AS CONSTRUCTED
 Hembrow's Electrical Service Pty Ltd
 Name: Wayne Eddings Ph: (07) 3290 4899
 Signed: *Wayne Eddings* Date: _____

NBN CONDUITS & PITS

LOCATION
GAINSBOROUGH GREENS PRECINCT 7.3D
GAINSBOROUGH DRIVE
 PIMPAMA - 4209

DRAWING No.
C833-N-01B

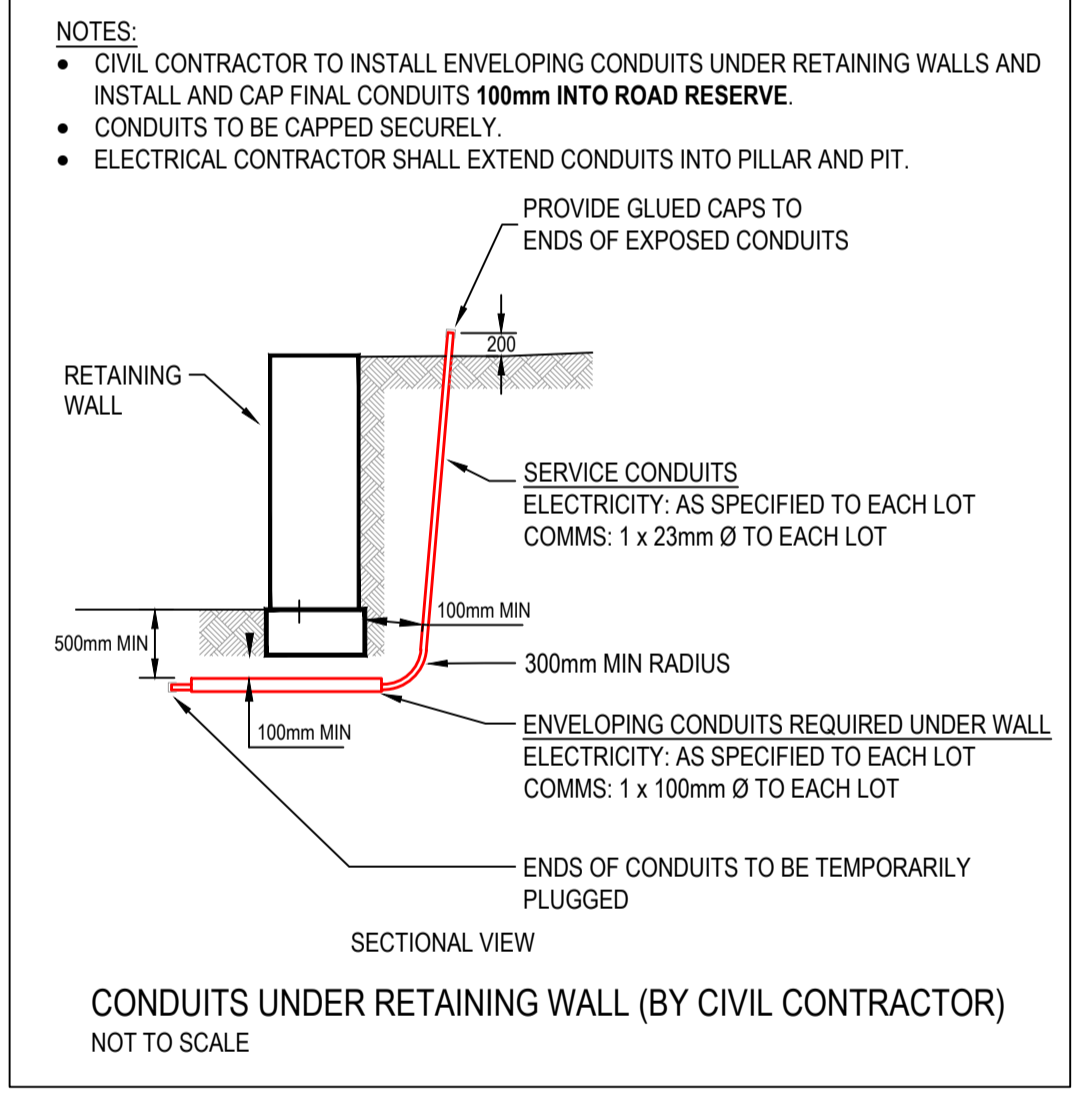
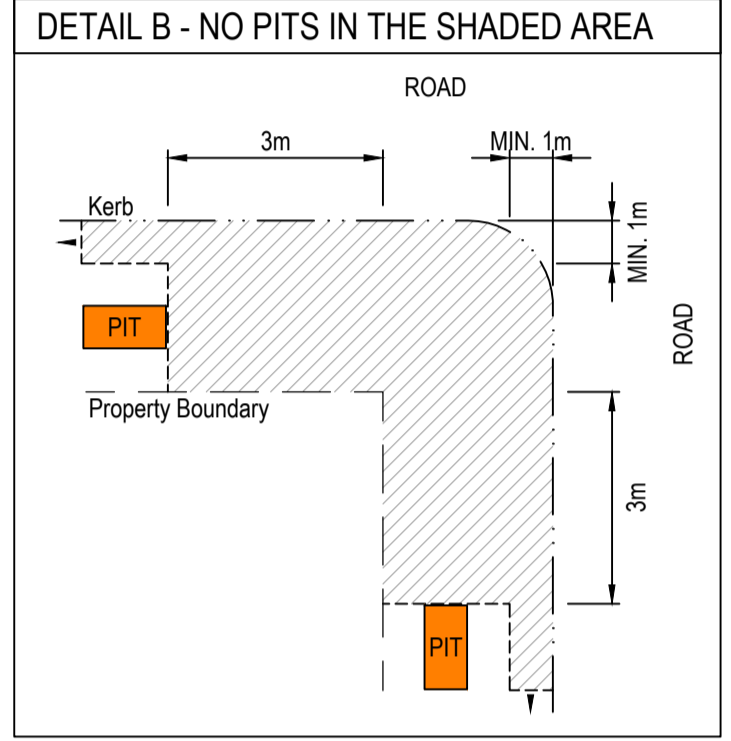
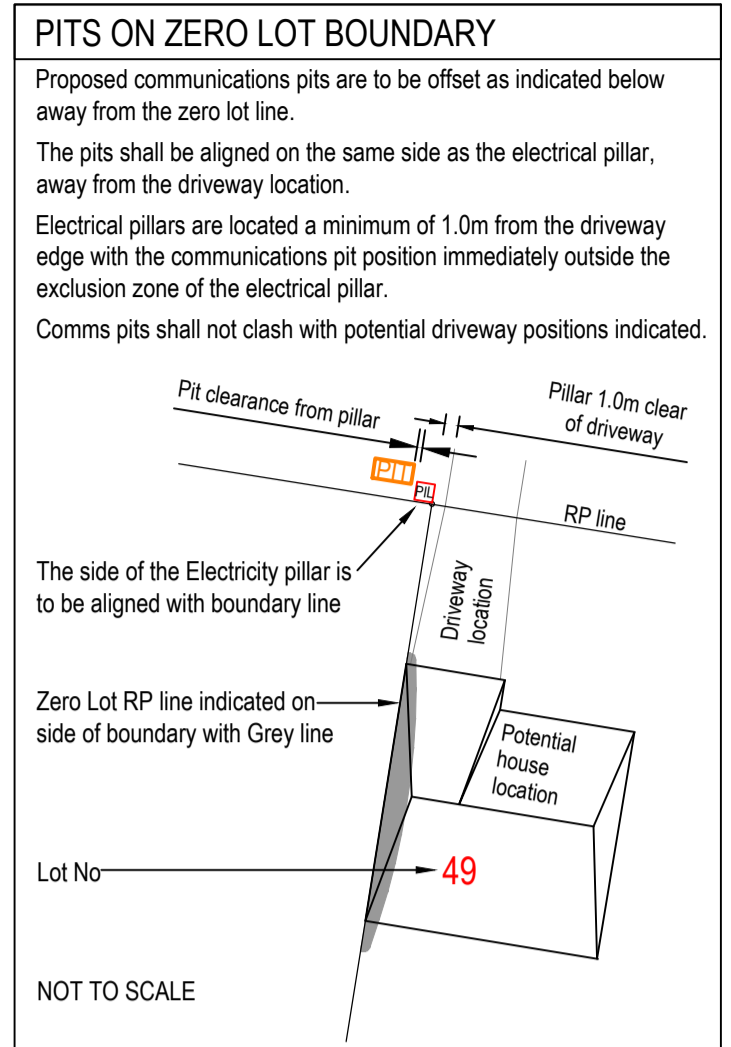
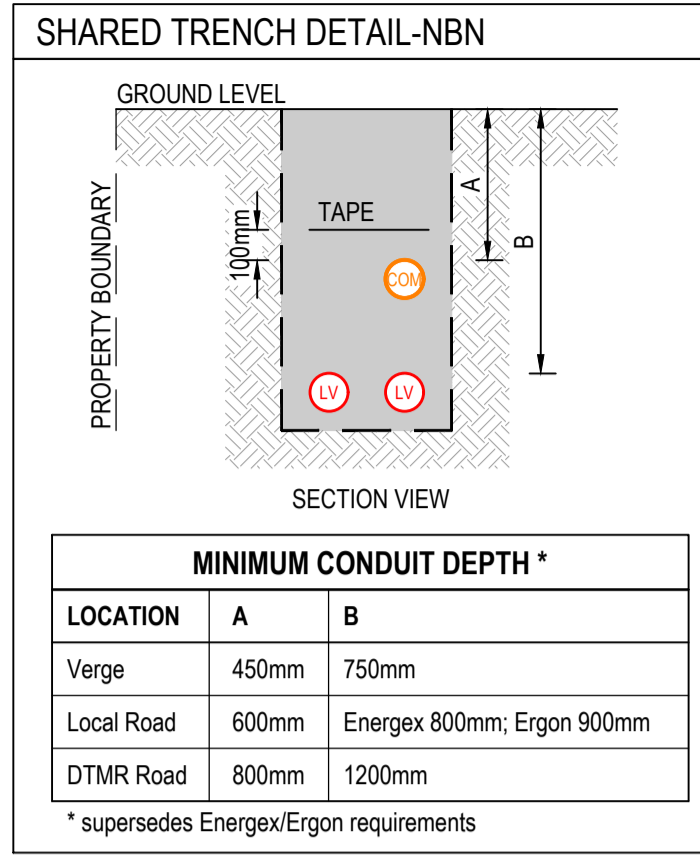
DATE	REV	REVISION	APP.	DATE	REV	REVISION	APP.	CURRENT REVISION CHANGES:
23/01/2019	A	ORIGINAL	RR					Rev B: PIT-001 to PIT-005 to be installed by NBN contractors.
03/08/2020	B	PIT-001 to PIT-005 INSTALLED BY NBN	RR
